Serial No.: 09/771,416

For: UNIVERSAL CLEAT

**PETITION FOR EXERCISE OF THE  
COMMISSIONER'S SUPERVISORY AUTHORITY**

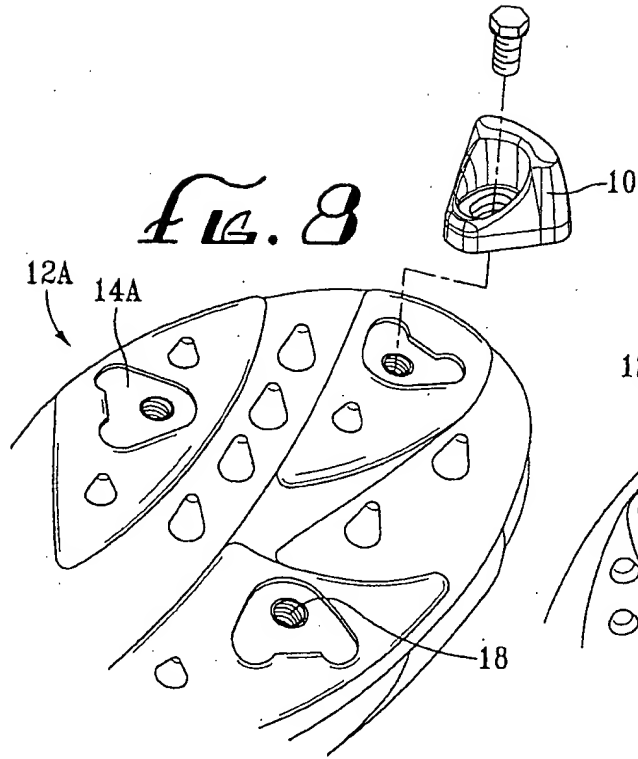
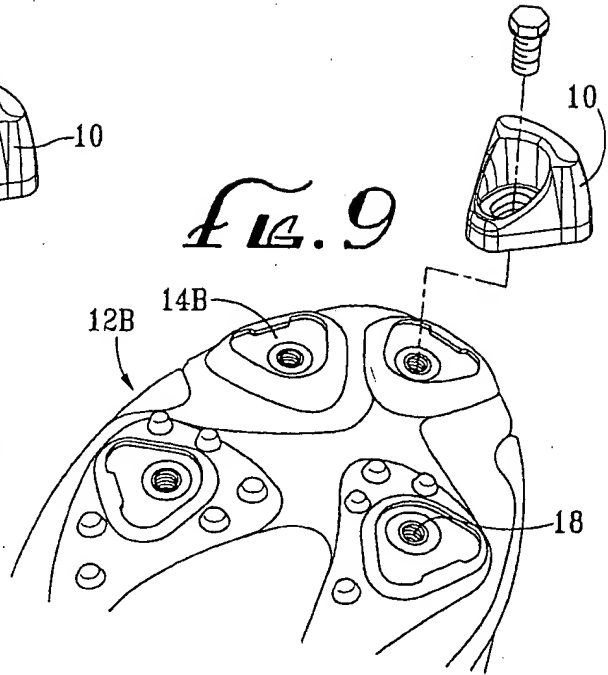
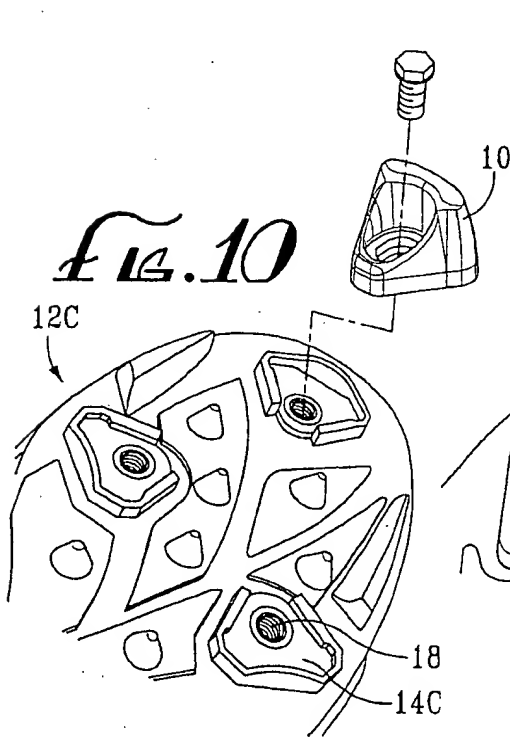
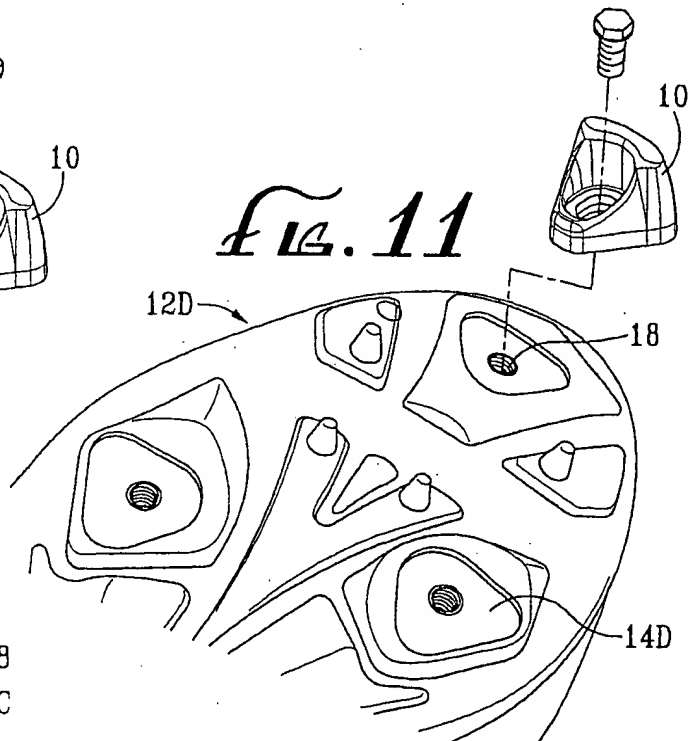
6. The amendment filed May 20, 2003 is objected to under 35 U.S.C. 132 because it introduces new matter into the disclosure. 35 U.S.C. 132 states that no amendment shall introduce new matter into the disclosure of the invention. The added material which is not supported by the original disclosure is as follows: The phrase "has a generally isosceles and /or equilaterally triangular shape recess formed about the receptacle" is not supported by the original disclosure.

With respect to the phrase "with a longest side of said three sides of said base being shorter than the longest side of any of said triangular recesses" Applicant has no support to claim it this way because this is only one possibility and not the only possibility that the Figures depict. Furthermore, since Figures 8-11 do not show the universal cleat completely sitting in the recess and the original specification does not teach the universal cleat completely fitting into the recess, it will not be clear to one skilled in the art that the longest side of said three sides of said base being shorter than the longest side of any of said triangular recesses since the cleat can be partially fitted into the recess and therefore, the longest side of the three sides of said base could be longer than the longest side of any of said triangular recesses.

10. Applicant's arguments filed August 04, 2005 have been fully considered but they are not persuasive. Contrary to applicant's arguments Figures 8-11 do not show the new limitations considered as new matter, see above arguments. Therefore these drawings can not be the basis for addition of descriptive material not shown by these drawings to the original written description.

Applicant respectfully invites the Commissioner to read the text set forth in Exhibit M against the structure illustrated in Figures 8 through 11 of the application as filed. From that reading it will be apparent that the text describes the structure shown in Figures 8 through 11, and nothing more. The text does not embellish or add to what is shown in Figures 8 through 11. The text only puts into words what the eye sees when looking at Figures 8 through 11. The text does not add any new matter to the application. The text only puts into words the structure shown in the drawings.

As principally shown in Figure 8, a first shoe 12a, One of the shoes provided by a first one of the manufacturers, has formed the bottom exterior surface an equilateral three-sided includes a generally triangular recess 14a formed in the sole around about the threaded receptacle 18, sides of the generally triangular recess 14a extending transversely outwardly from the sole shoe bottom exterior surface, with vertices of the generally triangular recess 14a being rounded, two of the sides being straight linear and a third side having defining an inset inboard of the a line which, if drawn, would connect two of the vertices in a the same manner as identically to that of the straight linear sides.

As shown in Figure 9, a A second shoe 12b, provided by a second one of the manufacturers, has a generally equilaterally triangular shaped raised portion extending outwardly respecting the sole, bottom with sides of the triangularly shaped raised portion sloping inwardly relative to the triangularly shaped raised portion with increasing distance from the sole bottom. The vertices of the triangle generally triangular recess 14b are rounded. Outer edges of two Two of the sides of generally triangular recess 14b are straight triangular or linear and a third side defines has an inset inboard of a line which, if drawn, would connect two of the vertices in the same manner as identically to that of the straight linear sides. The triangularly shaped raised portion is positioned around about the threaded receptacle 18 formed in the sole bottom, with the threaded receptacle 18 substantially midway between the center of the triangularly shaped raised portion and a vertex connecting the two straight sides linear edges.

As shown in Figure 10, a third shoe 12c provided furnished by a third one of the manufacturers, has a portion of generally triangular rib configuration extending raised transversely from the sole bottom and surrounding the threaded receptacle 18. adjacently to Generally triangular rib is open, the two ends of generally triangular rib stopping short of where one vertex of the generally triangular rib configuration would be if the two sides of the generally triangular rib leading theretowards were extended to intersect. The two sides of the generally triangular rib configuration are of equal length and are connected by a third side having a continuous arc is swung from the top of the third side in a plane parallel to the third side and perpendicular to the sole, about the receptacle. The two equal length sides of the triangular configuration, if extended to intersect, would be defined by vertices, terminating short of intersection and being connected by straight line edges of the portion of generally triangular configuration, to a third side of the triangular configuration. The generally triangular rib includes an upstanding lips extending inwardly toward the center of the triangle and parallel with the sole from the tops of each of the two equal length sides, bordering the triangular portion remote from the receptacle with edges of the lips bounding bordering the two equal length sides of the triangular portion, and stopping short of intersection vertices of said triangular rib.

As shown in Figure 11, a fourth shoe 12d, provided by a fourth one of the manufacturers, has a generally triangular recess 14d formed about threaded receptacle 18. Vertices of generally triangular recess 14d are rounded and sides of the recess are straight with two equal length sides being substantially the length of the straight sides of generally triangular recess 14b of second shoes 12b. The third side is longer than the equal length sides. The third side is straight.
